**RE: Ekins East Mine M/049/032, Utah County, Utah  
Notice of Intent to Commence Large Mining Operation  
Responses to Comments**

**Responses to  
Review Comments**

**RESPONSE TO INITIAL REVIEW COMMENTS  
FOR  
EKINS EAST MINE M/049/032, UTAH COUNTY, UTAH  
INTERMOUNTAIN AGGREGATE CORPORATION**

**CROSS SECTIONS**

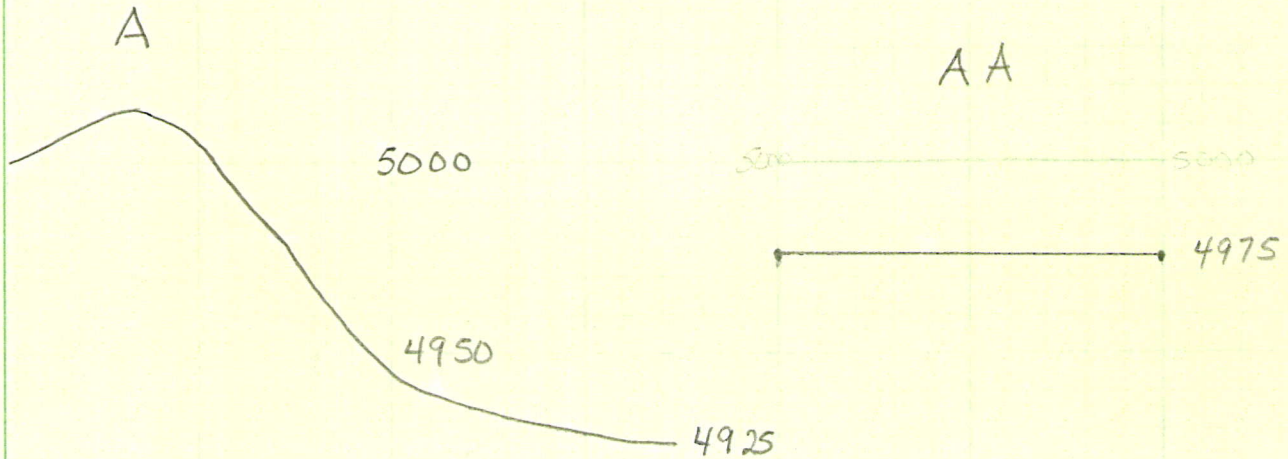
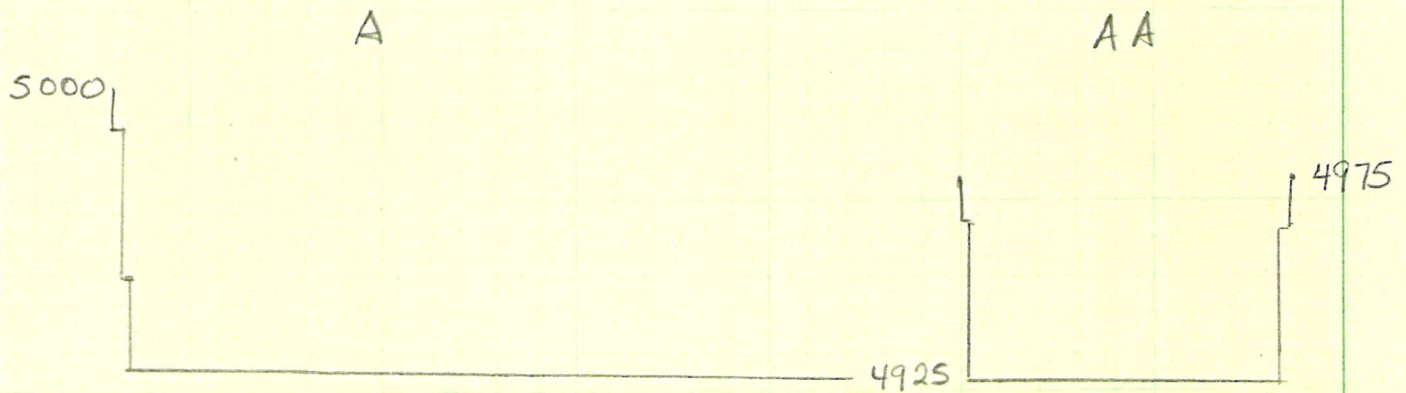
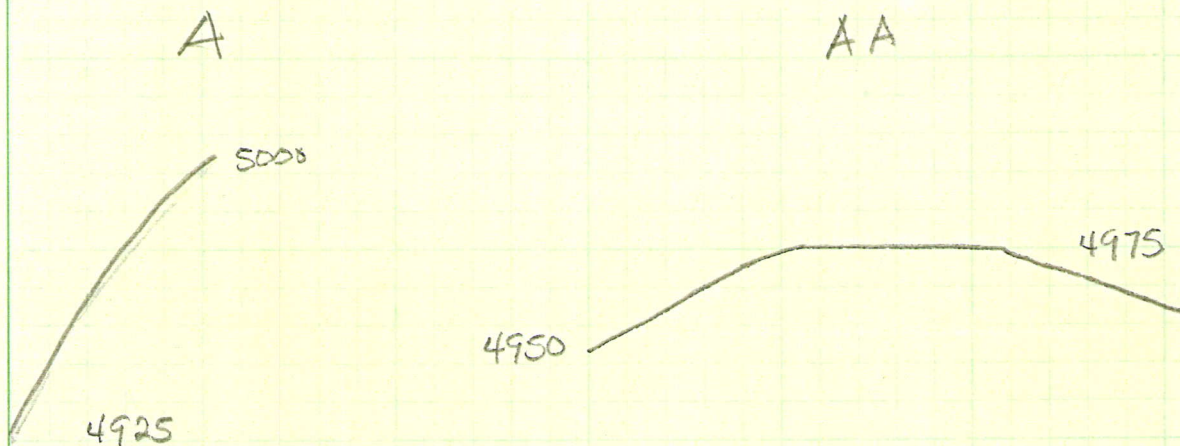
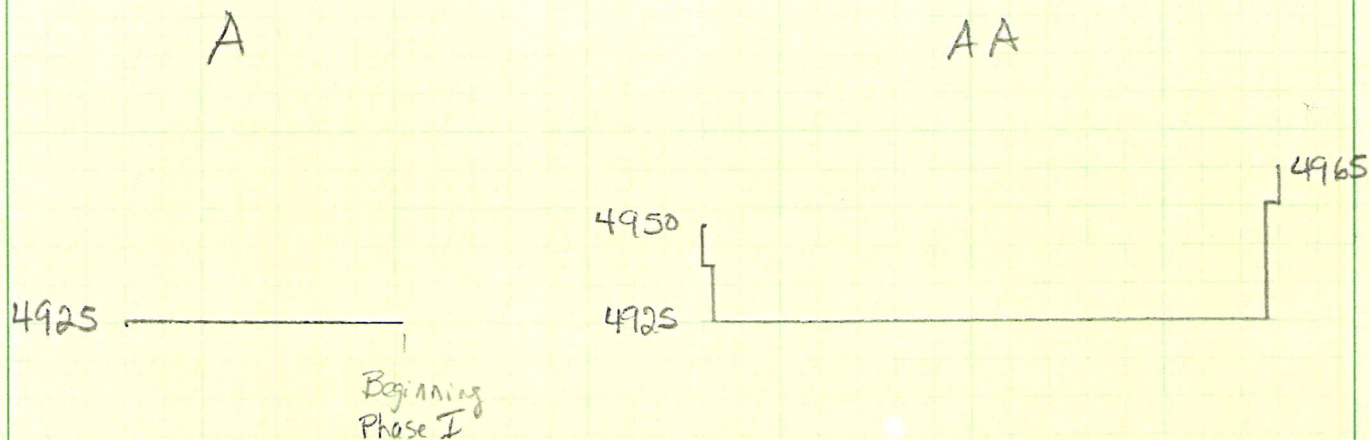
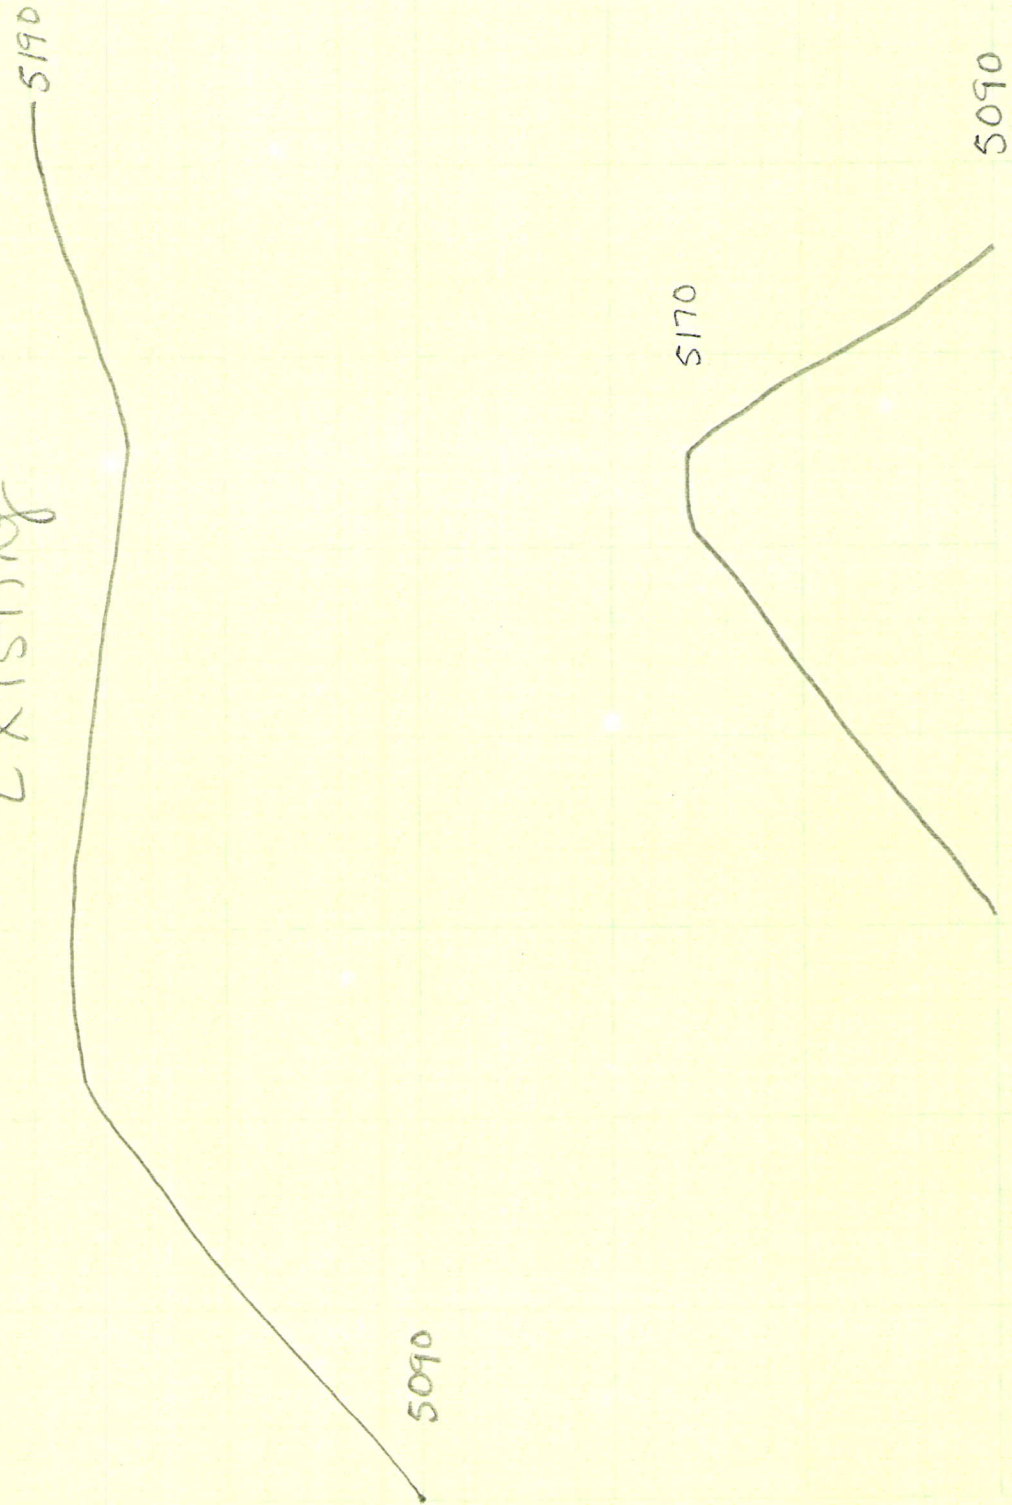
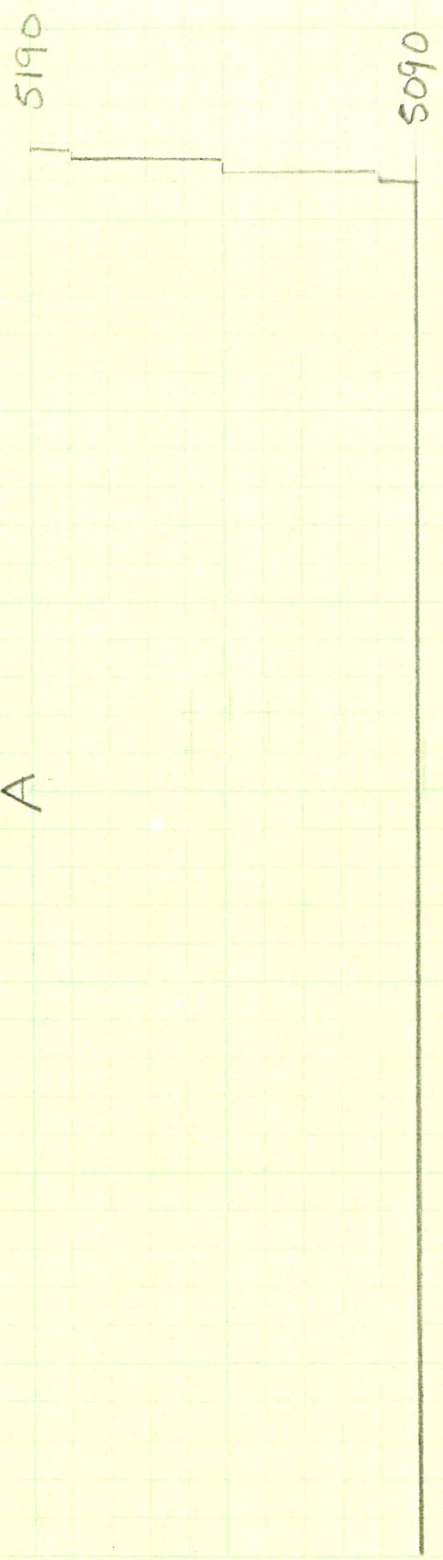
- 105.3 Comment: *Provide two cross sections for each of the main quarry excavations.*

- 109.4 Comment: *Provide a description of the highwall configuration at each pit after reclamation has been completed. Include typical bench widths, bench heights, inter-bench angles, total pit depth, and overall pit highwall angle in these pit descriptions.*

Response: Please see Exhibit C detailing these cross sections. As we do not anticipate long-term storage of material in the spoils area, we did not provide cross section details of this area.

5,000; the finished pit floor elevation will be 4,295. In the Phase III area, the highest existing contour is 5190; the pit floor elevation at the end of year 5 will be 5090. As depicted on the cross sections (Exhibit C), there will be a 10-foot-wide bench at the first 10 feet of depth of excavation, then a 40-foot excavation depth with a 10-foot-wide bench. Around the perimeter of the quarry walls will be placed 4-foot to 6-foot diameter boulders arranged along side one another. As the first bench occurs at a depth of 10 feet, should someone make his way past the boulders and fall, the distance of his fall would only be 10 feet.

Response: Please see Exhibit C which depicts the proposed cross sections of the three mining areas. The first lift will be at a depth of 10 feet, creating a vertical highwall of 10 feet, followed by a bench 10 feet in width. Thereafter, lifts will be 40 feet followed by 10-foot benches.
